UNITED STATES PATENT AND TRADEMARK OFFICE

APPLICATION NO.	FILING DATE	FIRST NAMED INVENTOR	ATTORNEY DOCKET NO.	CONFIRMATION NO.
10/601,332	06/20/2003	Ubaldo Mastromatteo	2110-46-3	6985

Office Action Summary	Application No. 10/601,332	Applicant(s) MASTROMATTEO ET AL.	
	Examiner A. J. HEINZ	Art Unit 2653

Addendum A

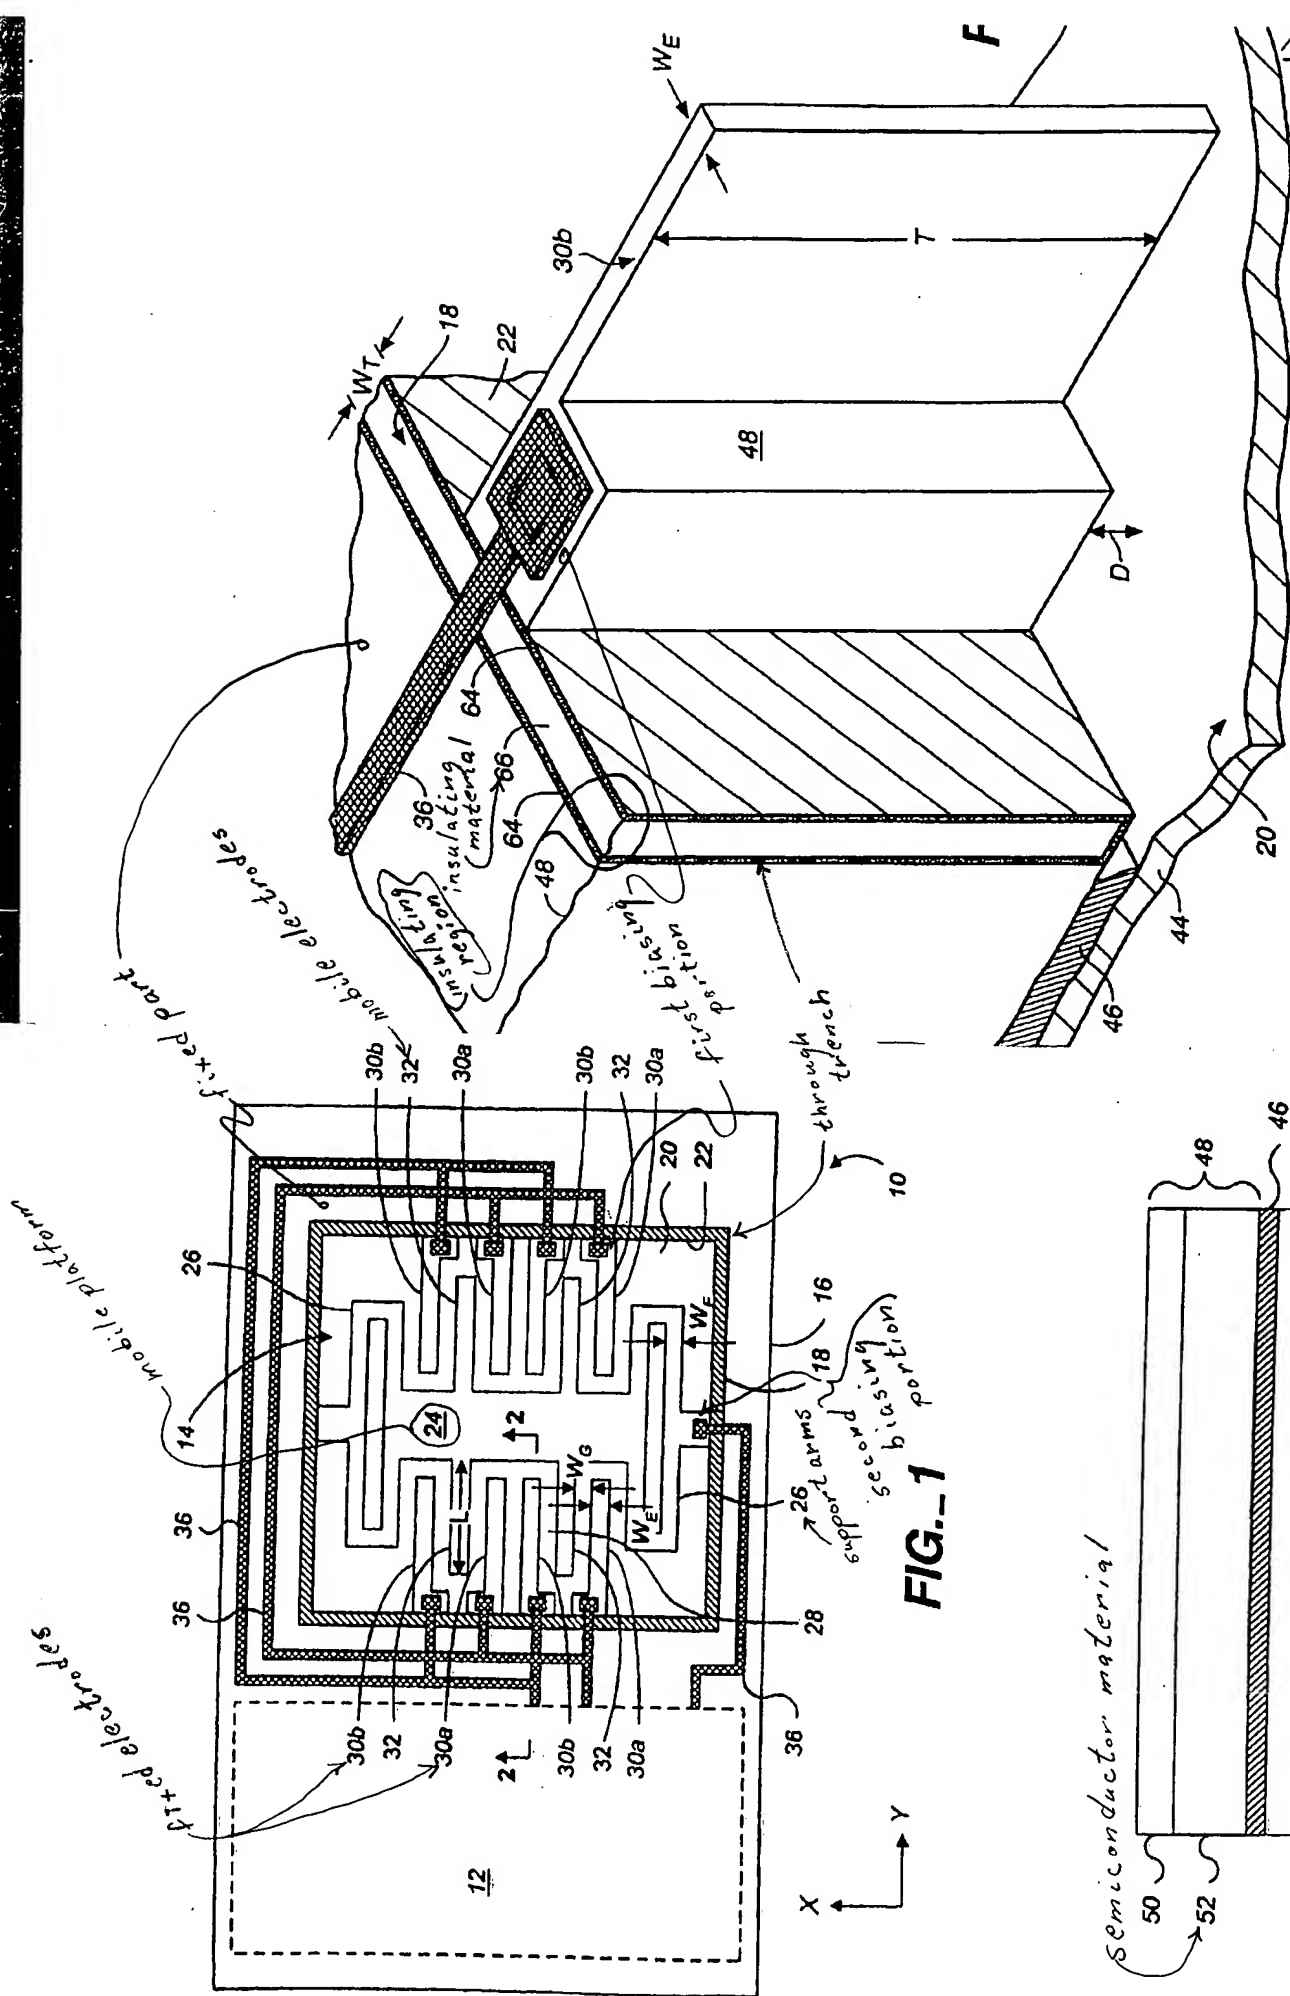
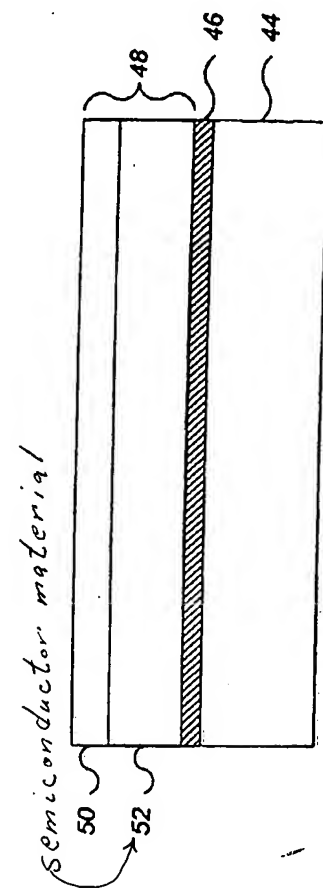
4. Claims 1-3,6,7,9,17-19 are rejected under 35 U.S.C. §102(b) as being anticipated by Brosnihan.

See Figures 1,3&4. Note, to the extent claimed and understood, the structure as shown in Addendum A reads on and performs to the same degree as claimed.
